PART AFFECTED: TP164386 Magnet Mounting Bracket

REASON: To prevent first character garble due to armature sticking to pole pieces on the selector magnet assembly.

CHANGE: The manufacturing process for the TP164386 magnet mounting bracket is revised to eliminate the substance that causes the armature to hang up.

TP164386 MAGNET MOUNTING BRACKET

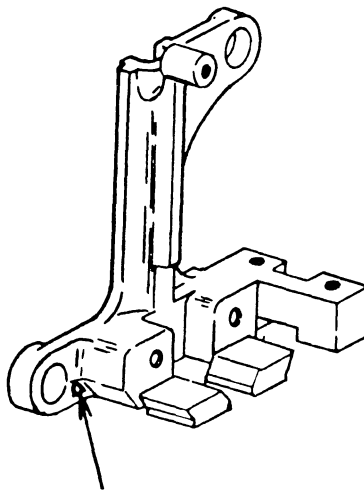
IDENTIFICATION: The TP164386 magnet mounting brackets manufactured by the revised process can be identified by the presence of a blue dot near the lower mounting hole. See Attachment Sheet 1.

**BLUE DOT IN THIS AREA INDICATES
TP164386 MAGNET MOUNTING BRACKET
MANUFACTURED BY THE REVISED PROCESS.**
